DART SERVICE INSTRUCTION

TO AMEND INSTALLATION INSTRUCTIONS D350-607-3 Rev.D,
INSTALLATION INSTRUCTIONS D350-607-4 Rev. C AND
INSTRUCTIONS FOR CONTINUED AIRWORTHINESS ICA-D350-607 REV. 6
REF TCCA STC: SH94-14
REF FAA STC: SR00213NY
REF EASA STC: EASA.10016996
REF BRAZILIAN STC: 2007S03-03/-04/-05/-06

A	NEW ISSUE	AJS	14.05.16
REV.	DESCRIPTION	BY	DATE
DESIGN	AJS	DART AEROSPACE LTD HAWKESBURY, ONTARIO, CANADA	
DRAWN	AJS		
CHECKED	N/A	DRAWING NO.	REV. A
MFG. APPR.	N/A	DSI 9699	SHEET 1 OF 2
APPROVED		TITLE	SCALE
DE APPR.		LUG REPLACEMENT	NTS
DATE	14.05.16	COPYRIGHT © 2014 BY DART AEROSPACE LTD THIS DOCUMENT IS PRIVATE AND CONFIDENTIAL AND IS SUPPLIED ON THE EXPRESS CONDITION THAT IT IS NOT TO BE USED FOR ANY PURPOSE OR COPIED OR COMMUNICATED TO ANY OTHER PERSON WITHOUT WRITTEN PERMISSION FROM DART AEROSPACE LTD.

FIGURE 1: INSTALLATION OF D4775-041 FWD STRUT

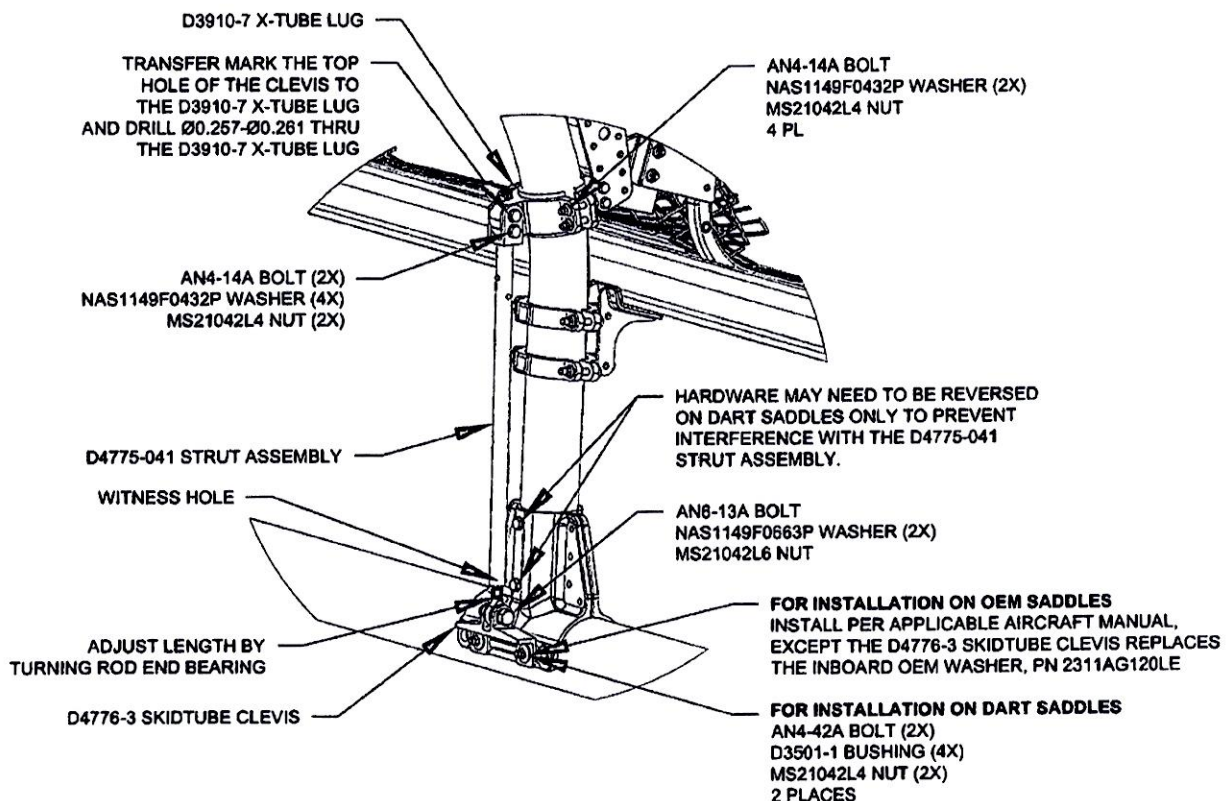
3.1 Substitute the Forward Lower D3910-5 X-Tube Lug with the D3910-7 X-Tube Lug as shown in Figure 1.

3.2 Install the forward D4775-041 Strut Assembly. Transfer mark from the upper hole on the clevis of the D4775-041 Strut Assembly to the D3910-7 X-tube Lug and drill thru the lug $\varnothing 0.257$ - $\varnothing 0.261$ as shown in Figure 1. Touch up chemical conversion coating per MIL-DTL-5541. Check the witness holes located at the bottom end of the D4775-041 Strut Assemblies to ensure that the thread from the rod end extends past the witness hole.
Torque MS21042L4/-4 nuts to 50-70 in-lbs (5.7-7.9 N-m). Torque MS21042L6/-6 nuts to 160-190 in-lbs (18.1-21.5 N-m).
